# PLAN CHANGE 12 – ENABLING HOUSING SUPPLY

Hamilton City Council

30 September 2022

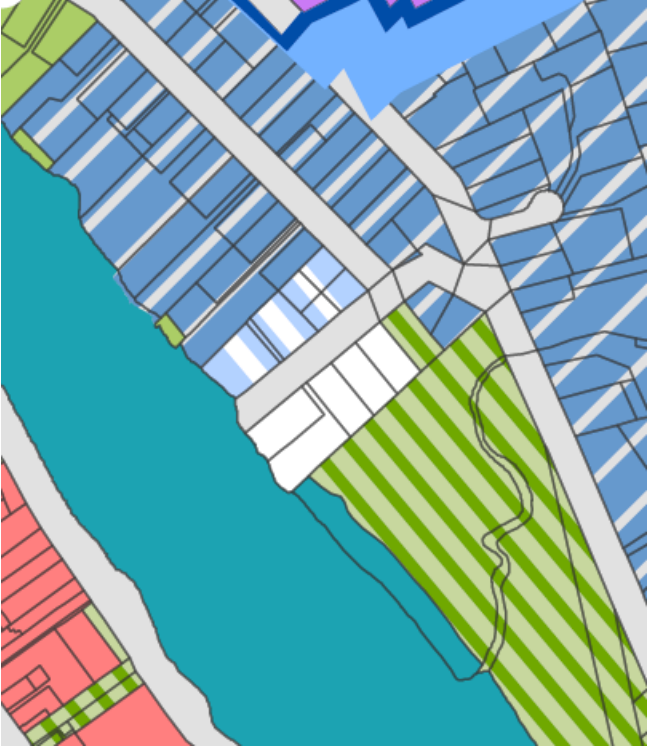
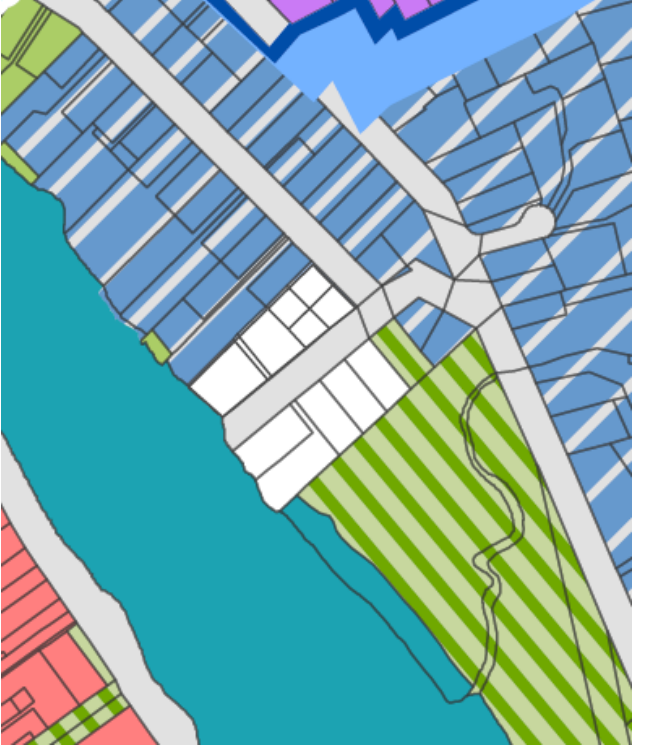
<p>Figure 25.14.4.1d</p>	<p>Figure 24.14.4.1 should be updated to be in accordance with guidance from Waka Kotahi. The figure should be renamed to “Lines of Clear Sight” and add a definition.</p>	<p>Amend Figure 25.14.4.1d to the following diagram and rename to “Lines of Clear Sight”:</p> <p><i>Figure 1: Sight distance measurement</i></p>  <p>The diagram illustrates sight distance measurement on a curved road. It shows a road with a driveway on the right side. A dashed line represents the 'centre of lane'. Two solid lines represent the 'sight distance' from a point 'A' on the road to points 'C' and 'D'. Point 'B' is also marked on the road. The diagram shows how the sight distance is affected by the curve of the road and the presence of a driveway.</p> <p>And add a definition for “lines of clear sight”.</p>

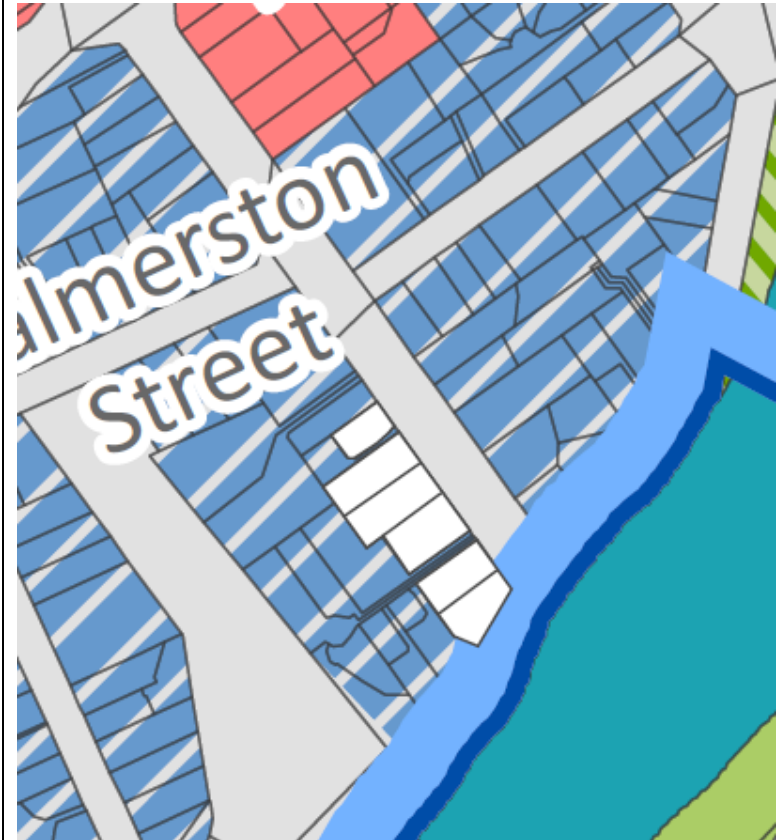
Provision	Commentary and Reasons	Relief Sought:
<p>Residential zones – Riro Street</p>	<p>Riro Street has a proposed Historic Heritage Area (HHA) overlain through Plan Change 9. Plan Change 12 has erroneously notified general residential zoning on the southern side of Riro Street and medium density residential zoning on the northern side.</p> <p>To ensure that the provisions of the HHA can be applied effectively and as they are intended, the medium density residential zoning should be amended to general residential zoning.</p> 	<p><b>Relief Sought:</b></p> <p>Amend the planning maps so that the medium density residential zone within the HHA over Riro Street is changed to general residential zoning.</p>

Residential zones – Anglesea Street

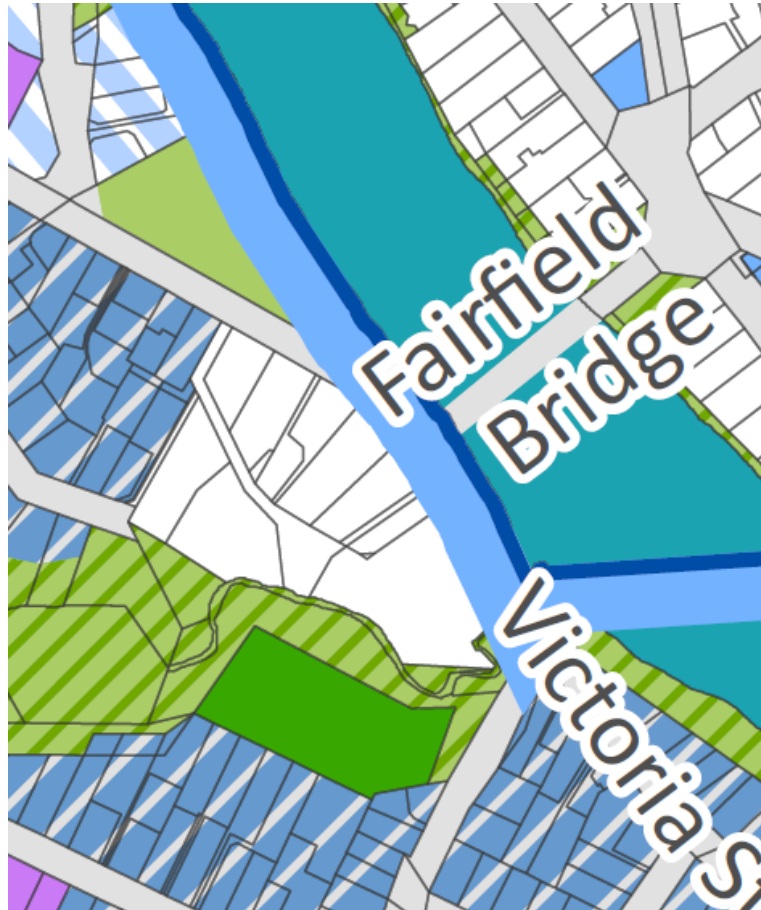
Anglesea Street has a proposed Historic Heritage Area (HHA) overlain through Plan Change 9. Plan Change 12 has erroneously notified high density residential zoning throughout this area.

To ensure that the provisions of the HHA can be applied effectively and as they are intended, the high density residential zoning should be amended to general residential zoning.

Amend the planning maps so that the high density residential zone within the HHA over Anglesea Street is changed to general residential zoning.

Residential zones – Parts of Victoria Street and Kotahi Ave

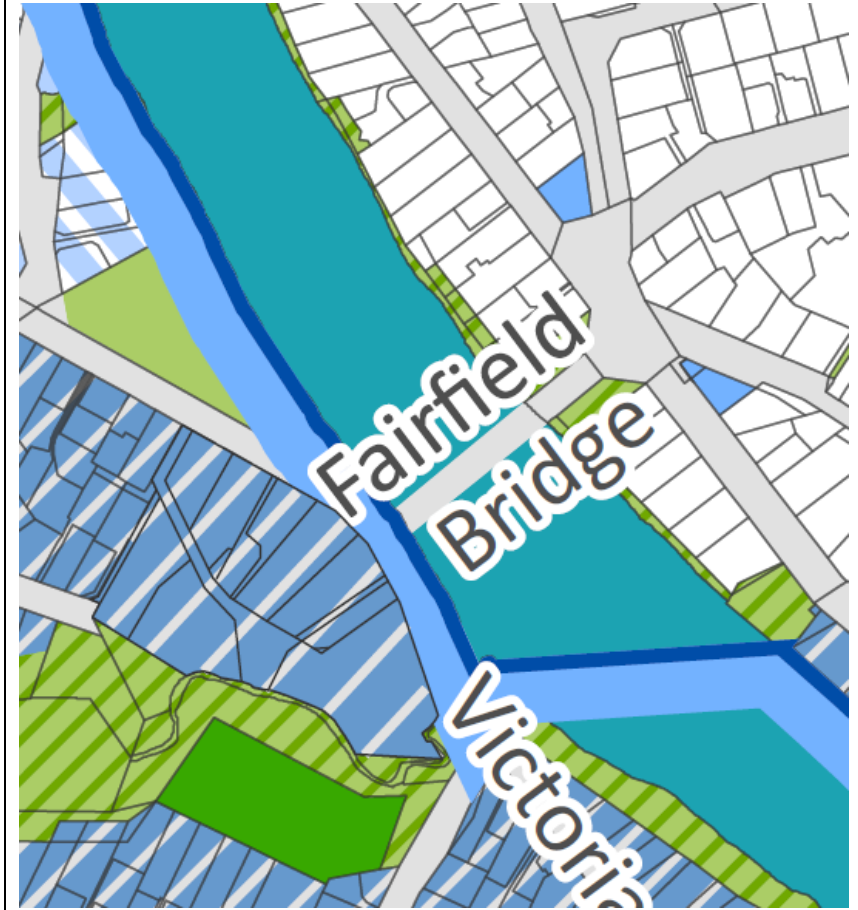
Plan Change 12 has erroneously notified the residential area on Victoria Street and Kotahi Avenue as general residential rather than high density residential zone. The area contains some built heritage items, an archaeological site, flood hazard and significant natural area. Nonetheless, supporting documentation to the plan change recommends that this area should be zoned high density residential.

Amend the general residential zone of the Victoria Street and Kotahi Avenue area to high density residential zoning.
